Alpine Street
Garage

11-15 ALPINE STREET
SOMERVILLE, MA

REVISION TO ZBA 2016-75
September 30, 2021

List of Changes; Refer to Accompanying Narrative.

Fourth Floor Plan

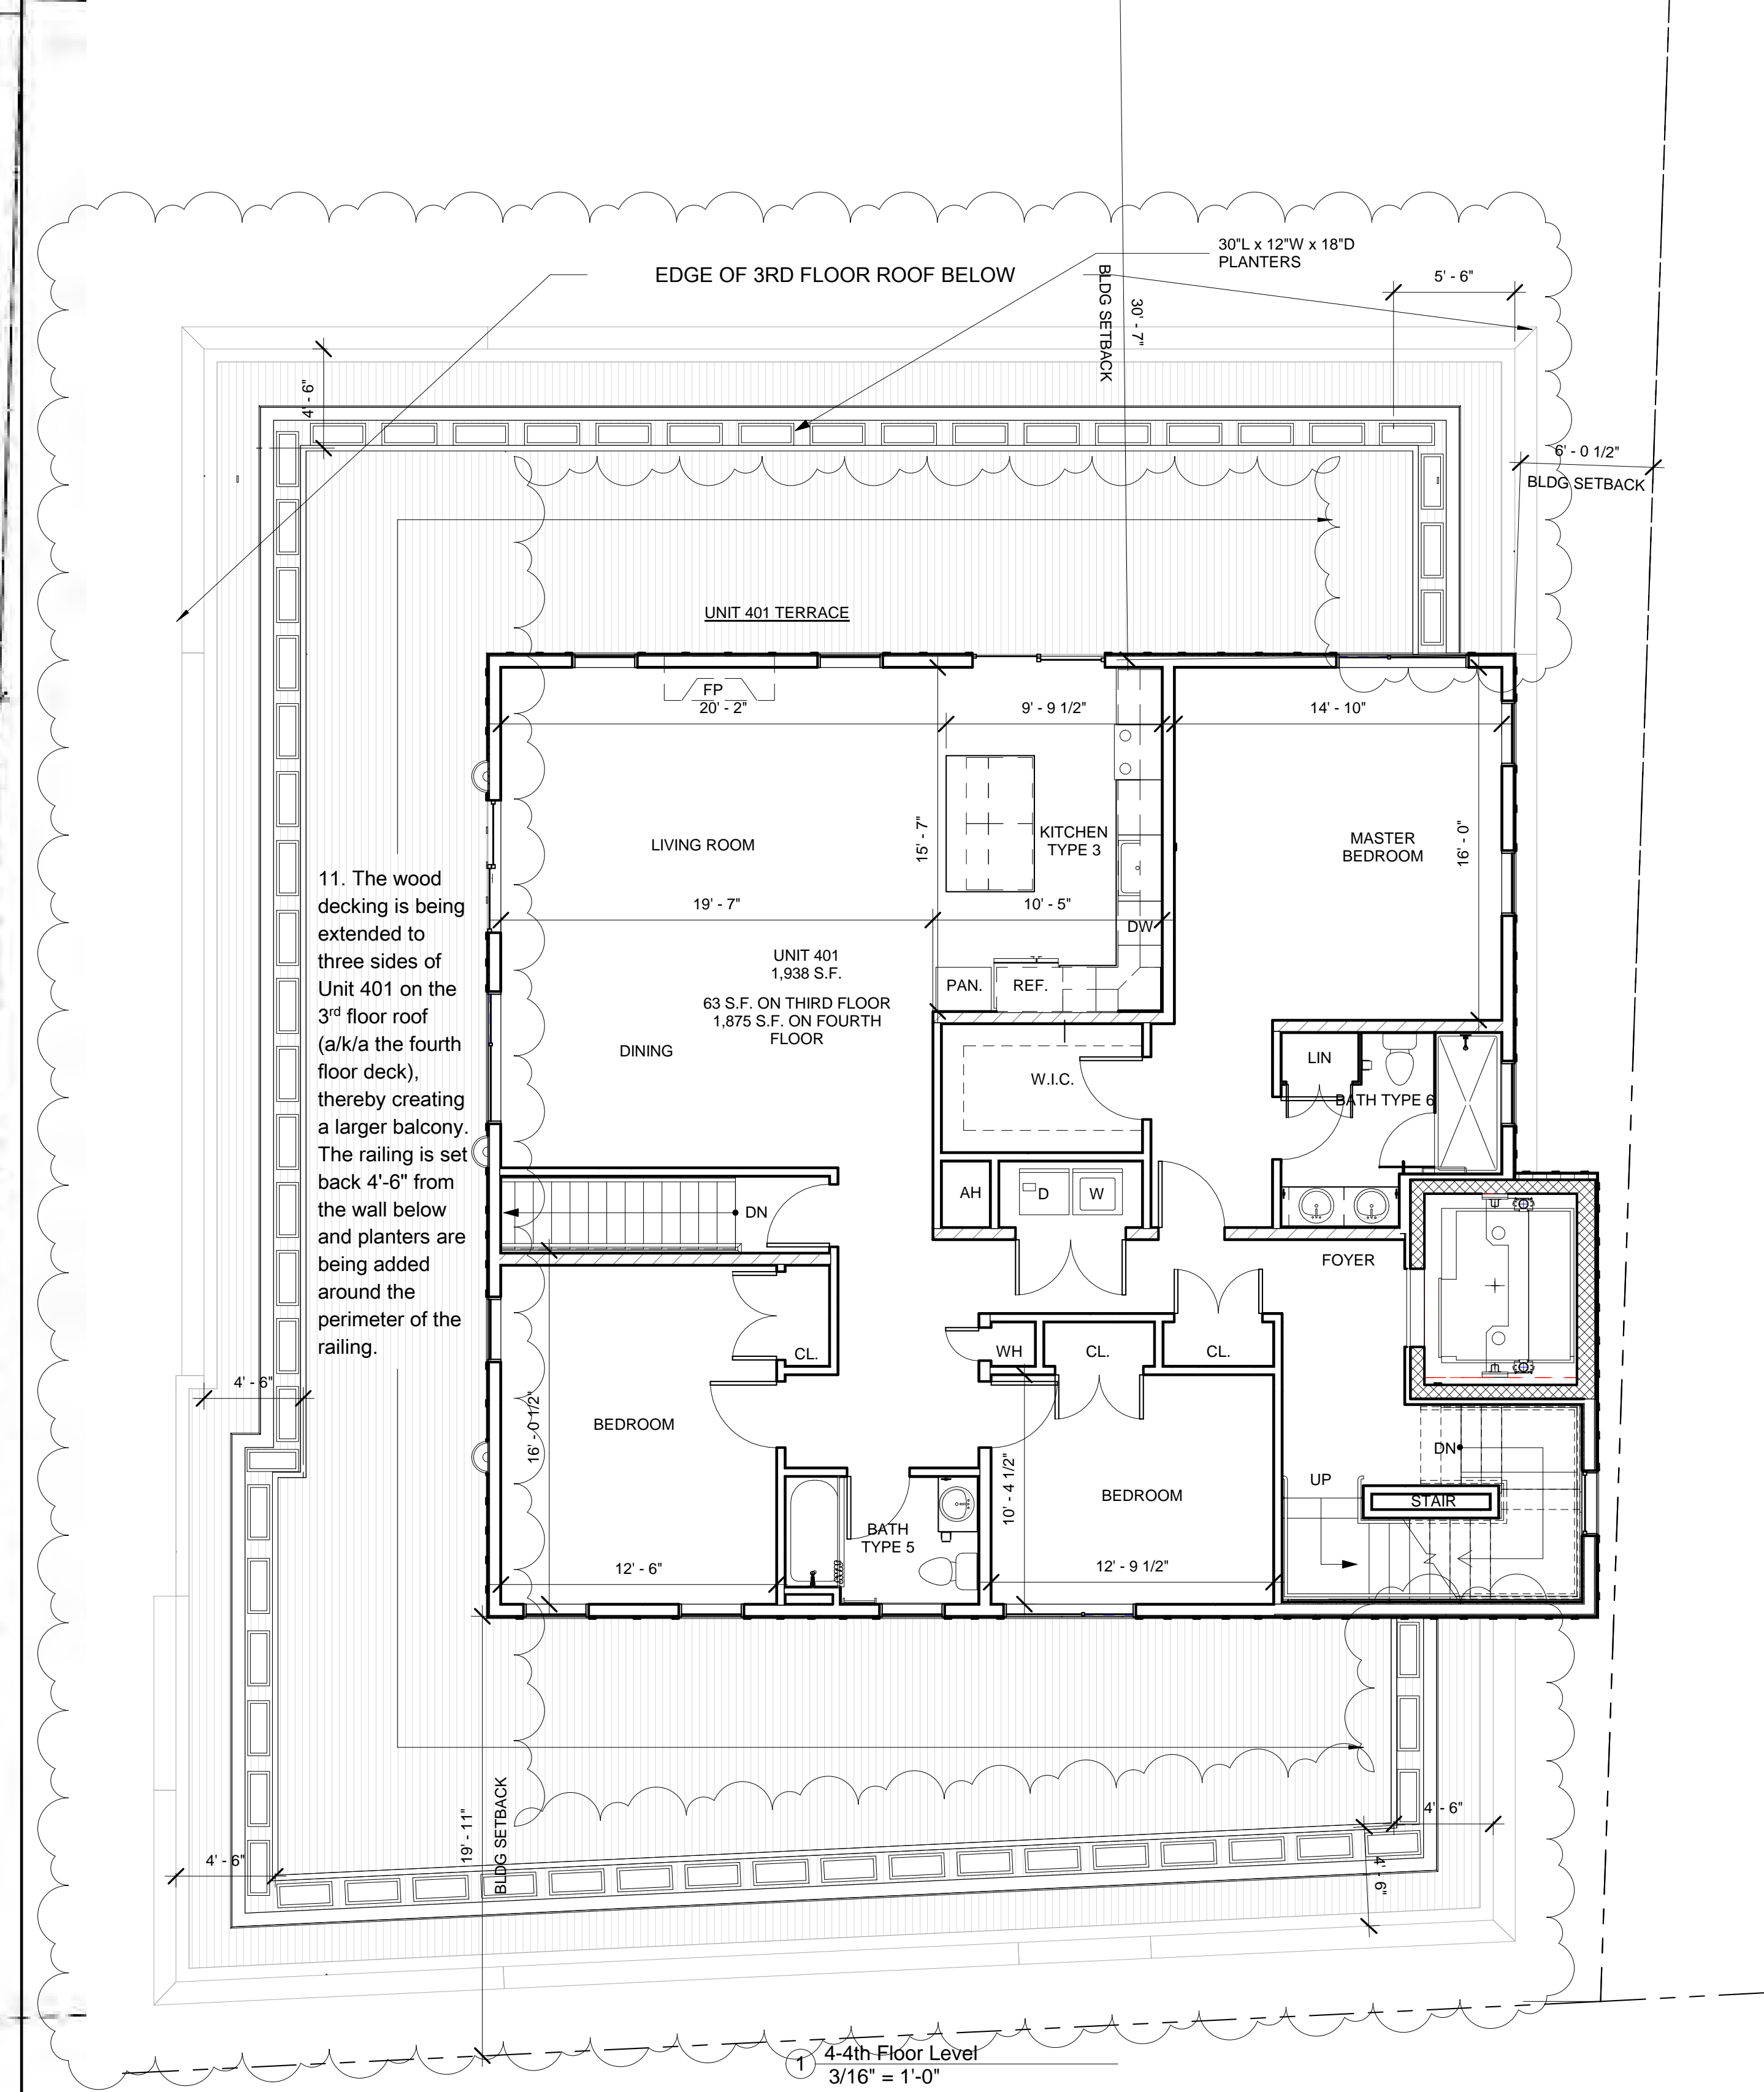
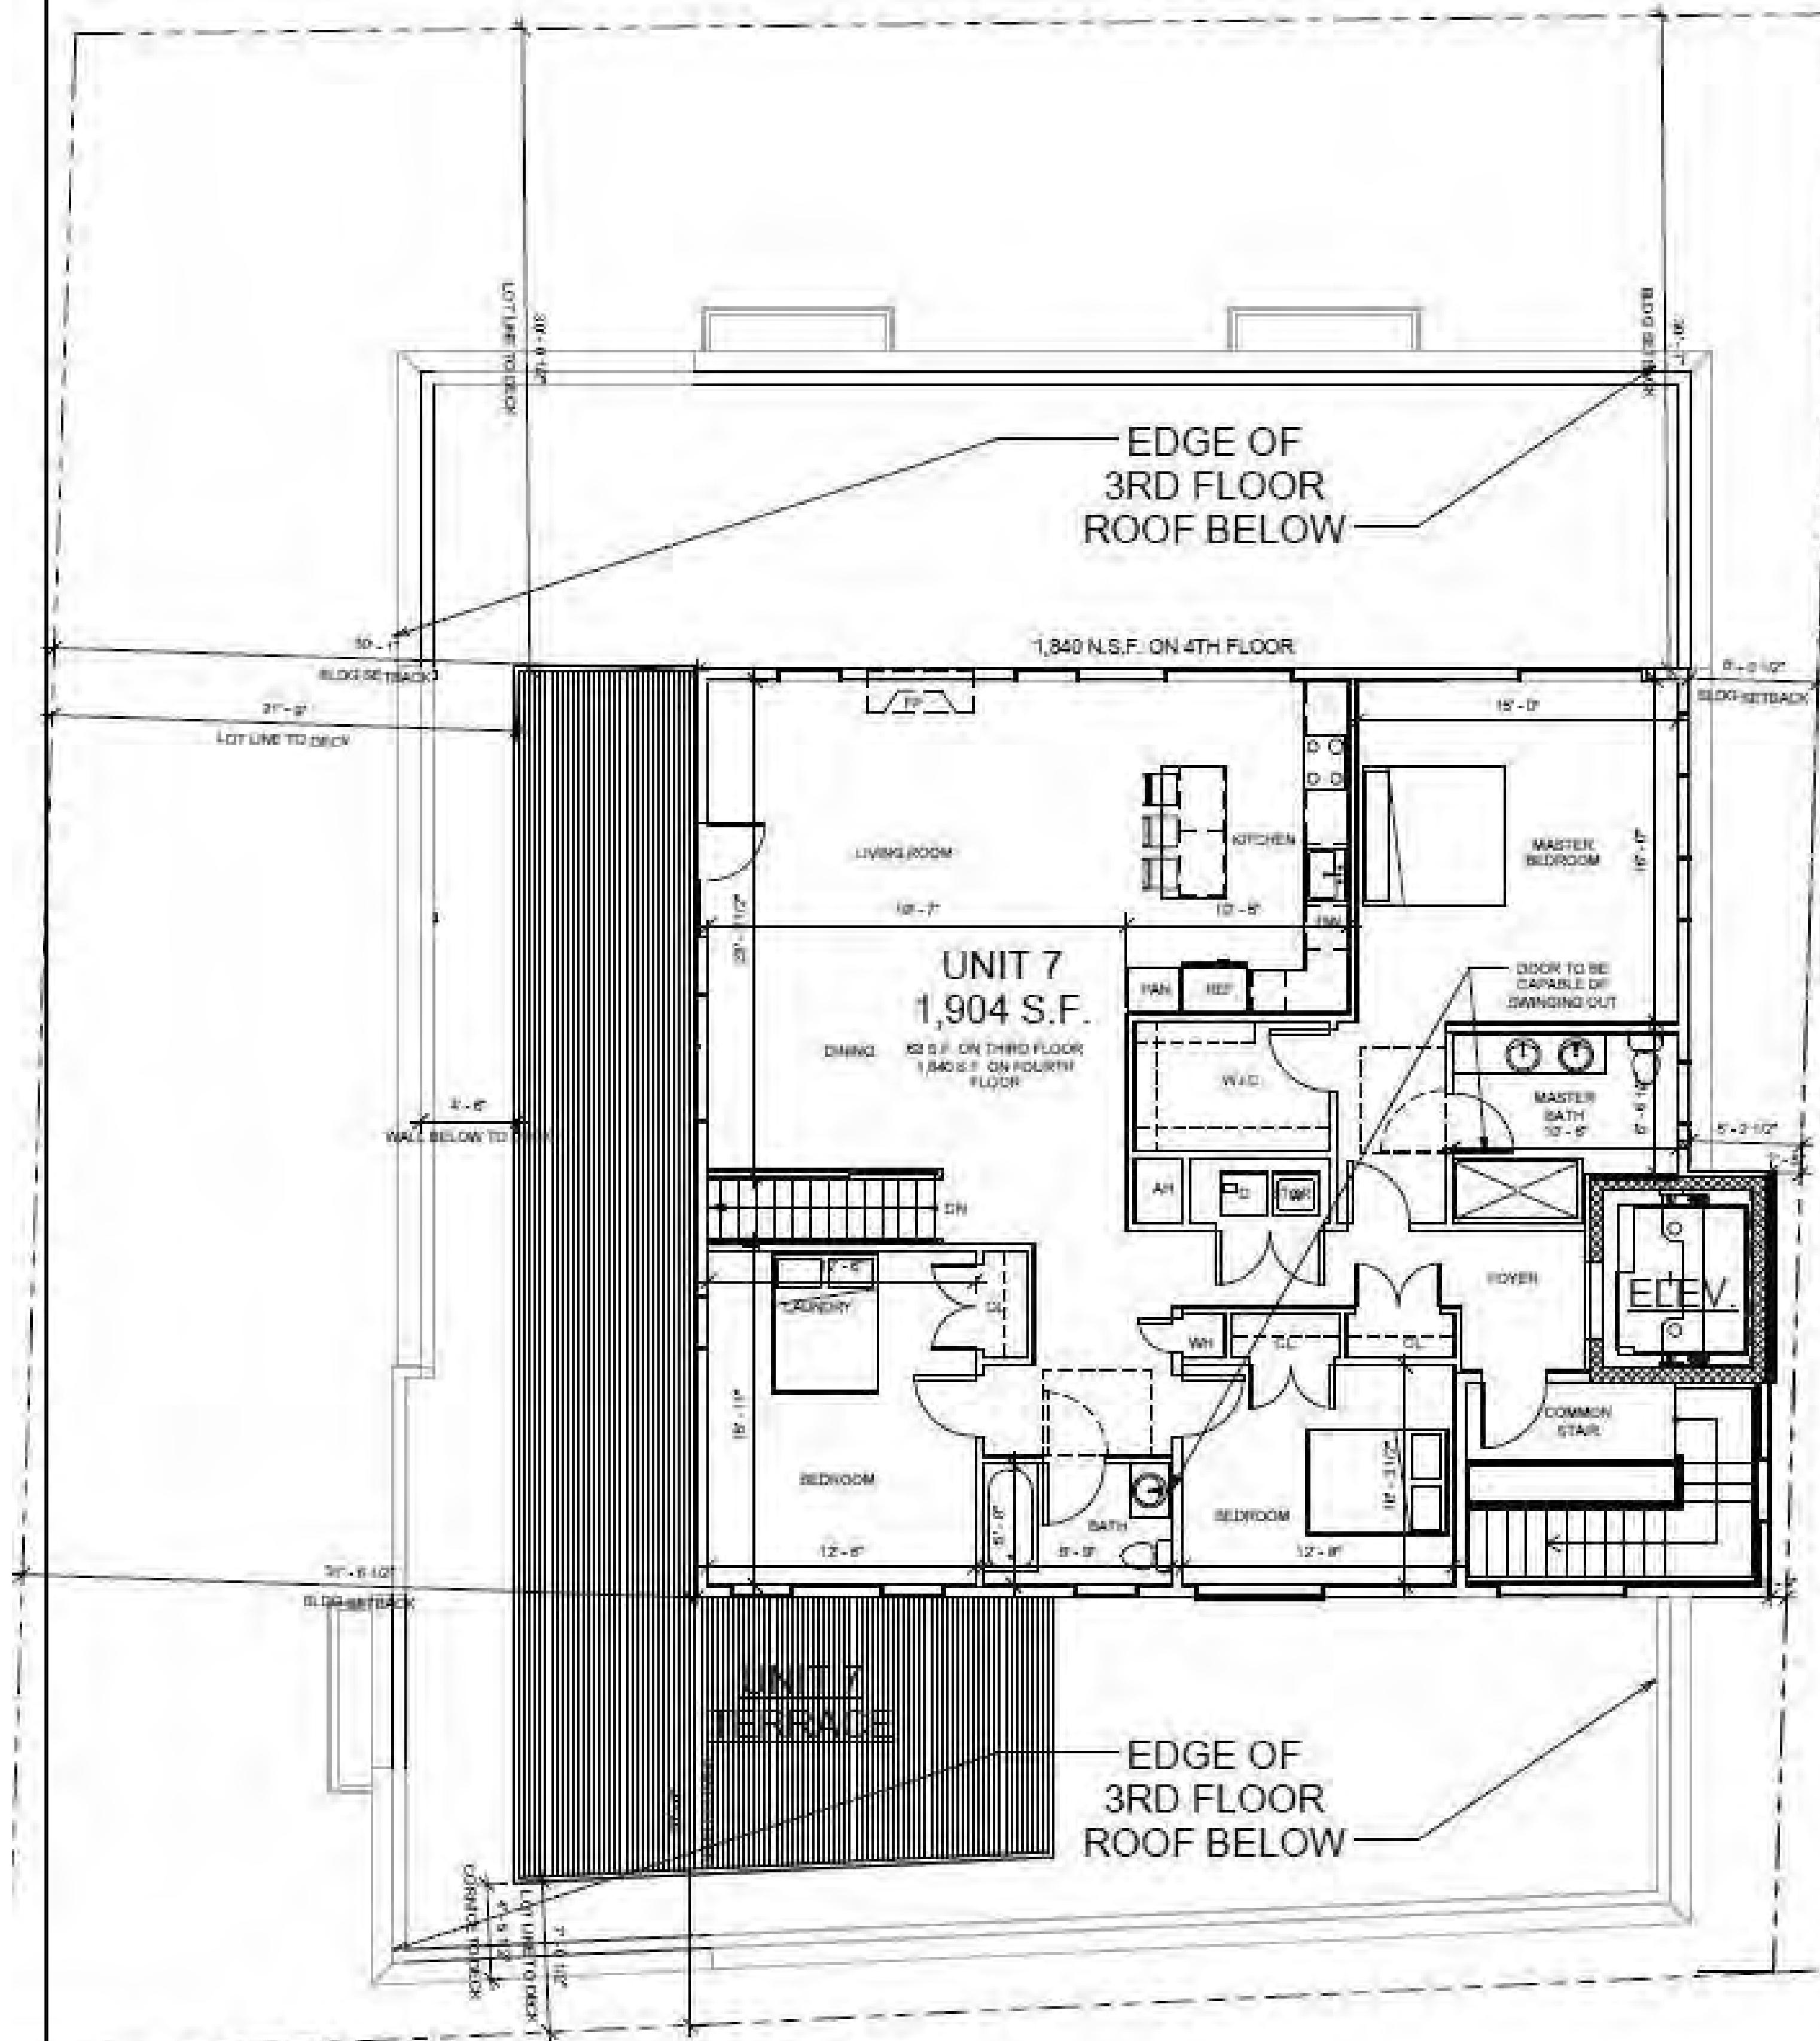
11. The wood decking is being extended to three sides of Unit 401 on the 3rd floor roof (a/k/a the fourth floor deck), thereby creating a larger balcony. The railing is set back 4'-6" from the wall below and planters are being added around the perimeter of the railing.

DESIGN INTENT: PLANTERS AROUND 4TH FLOOR TERRACE- ALIGN TOP OF PLANTERS W/ TOP OF RAILING AND CONSTRUCT A WALL AROUND PLANTERS. RAILINGS ARE TO BE SET BACK 4.5' FROM THE WALL BELOW
